SUBJECT: SAFETY RECALL OF SETRA S407 AND S417 MODEL COACHES

Ref.: **NHTSA # 13V-190**
Transport Canada # 2013-132
Setra Bulletin # TI 54.18U08765A

MODEL: TC 400
MODEL SERIES: 629540; 629557
TITLE: Removing the engine compartment light with socket

M54.18-0010-76

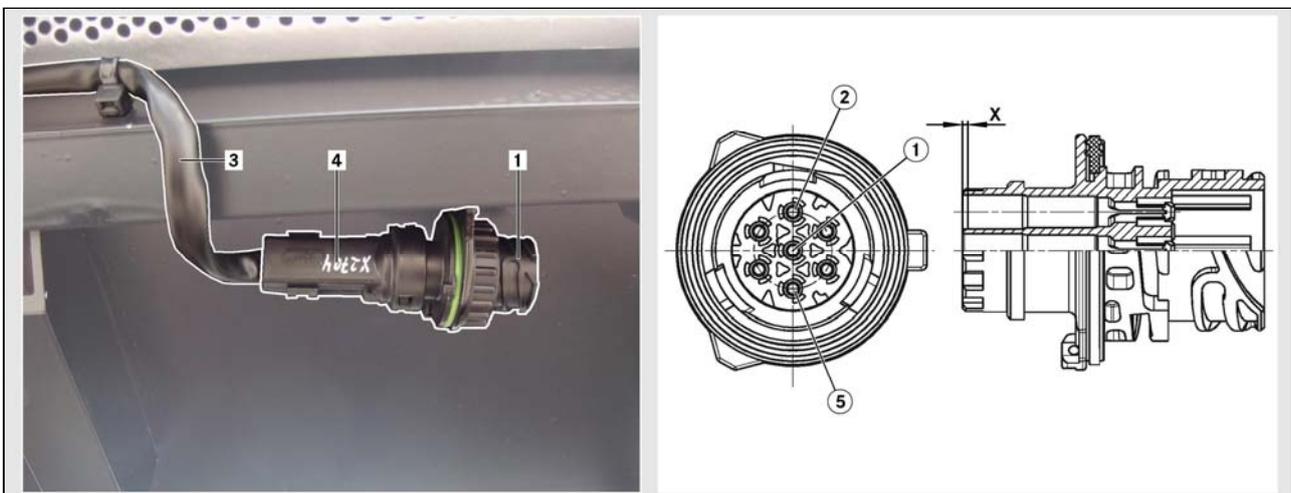
- Remove female housing (2) of engine compartment flap connection (X2704) from connector housing (1).

M54.18-0017-78

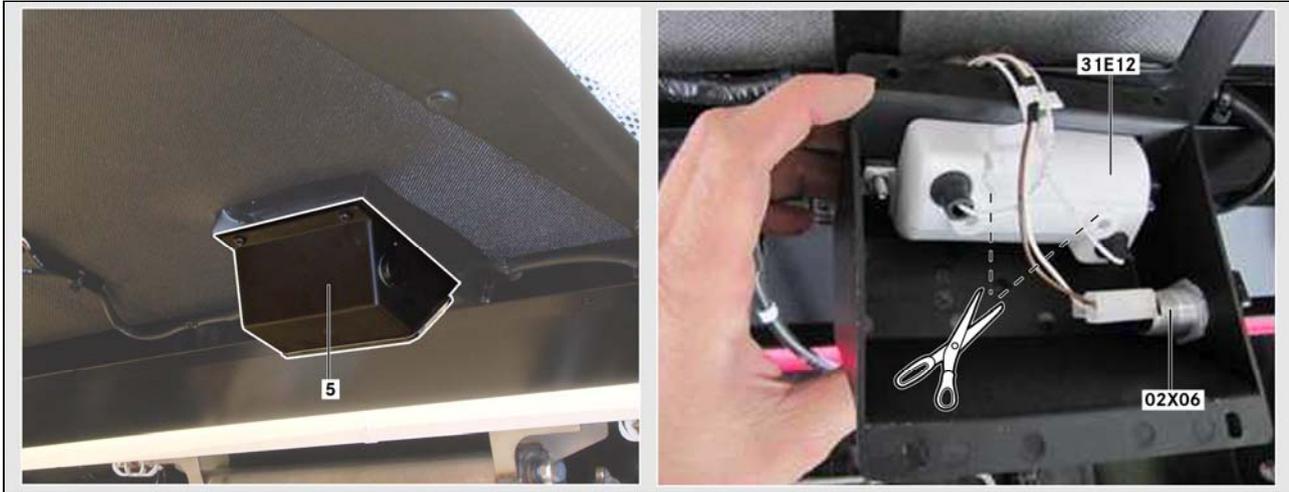
- Remove connector housing (1) with wiring harness (3) from the engine compartment flap.
- Remove cover cap (4) from the connector housing.
- Unpin lines 3076, 3022, 3021 from the connector housing, chambers (1, 2, 5).
- Fit blind plugs into the spare chambers of the connector housing.

i The installation depth of the blind plugs relative to the back of the housing must be at least 1 mm (dimension X).

M54.18-0018-78

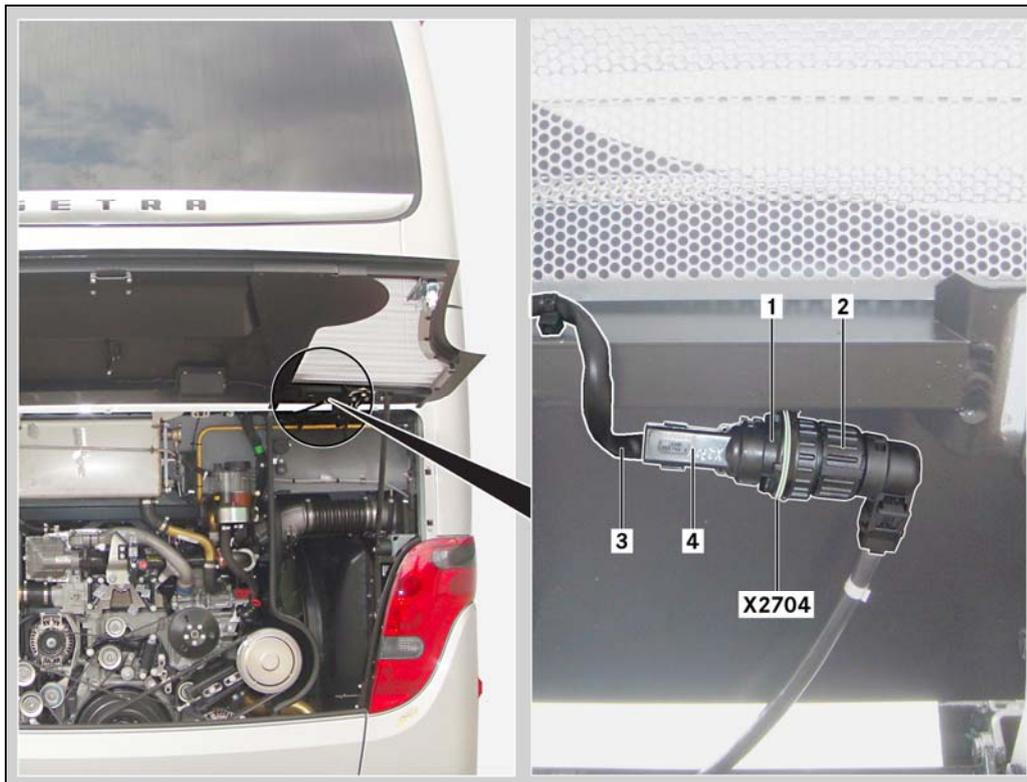
- Remove housing (5) of engine compartment light (31E12) with socket (02X06) from the engine compartment flap.
- Cut off the lines at the engine compartment light and socket and remove the housing.

i Cut off brown (BN) earth line of the socket near the wiring harness.

- Pull lines 3076, 3022, 3021 out of the wiring harness.
- Wrap the wiring harness with insulating tape.

M54.18-0019-76

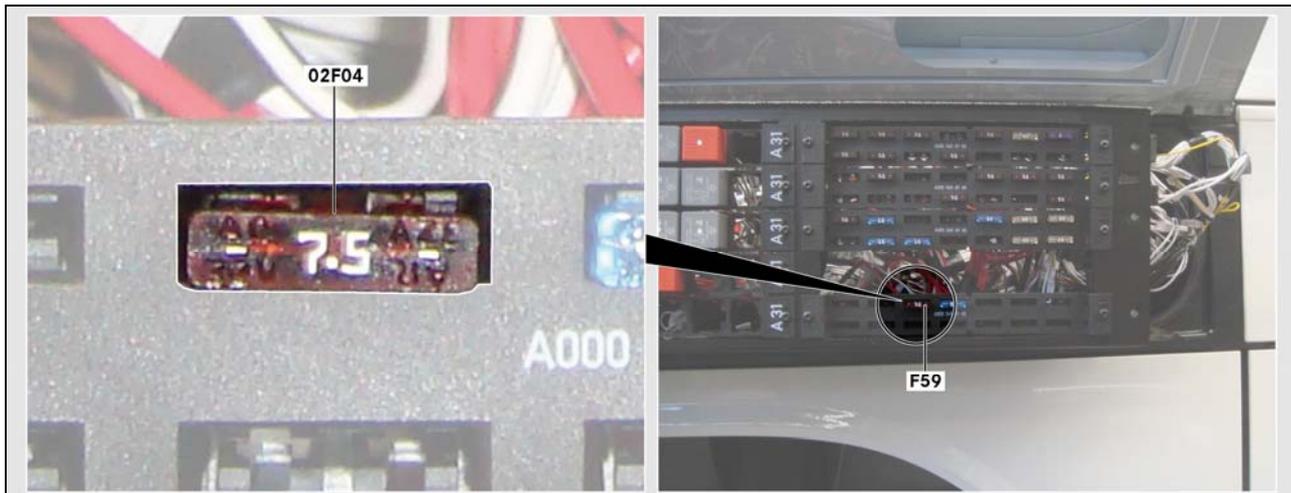
- Fit cover cap (4) to connector housing (1) and engage with the wiring harness.
- Fit connector housing (4) to the engine compartment flap and connect female housing (2).
- Fit wiring harness (3).
- Clean the bracket and holes of the housing fastening point on the engine compartment flap and spray with preservative agent.

M54.18-0020-78

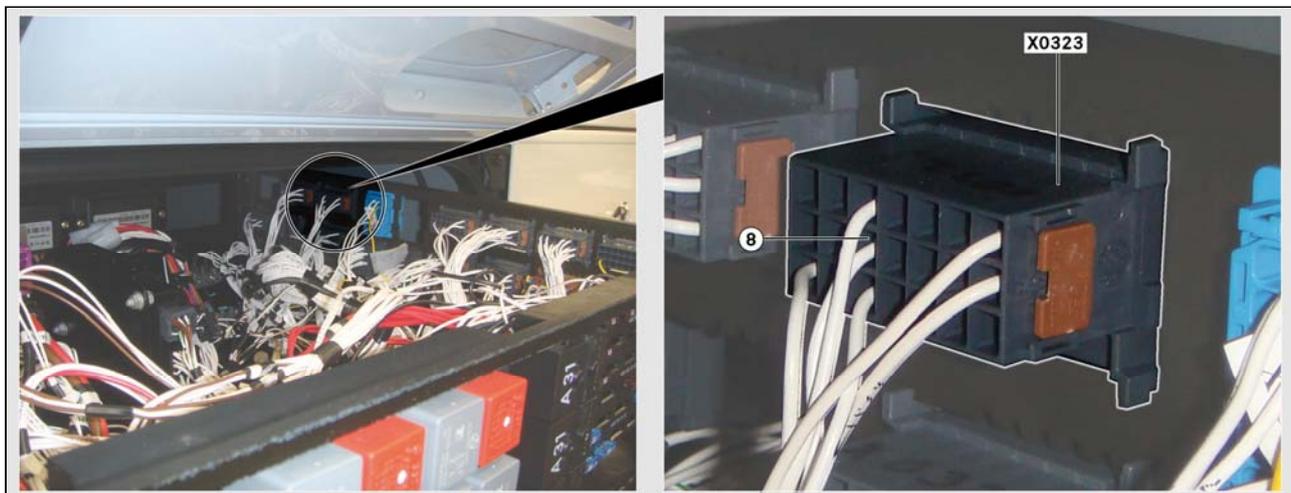
- Remove the engine compartment and lighting socket fuse (02F04) from socket (F59) on the auxiliary switch panel.
- Loosen the screws on the frame of the auxiliary switch panel and pull out the auxiliary switch panel.
- Unpin line (3076) at the socket of the removed fuse.

For safety reasons, the line (RD-0027) coming from the positive distributor must remain in the socket.
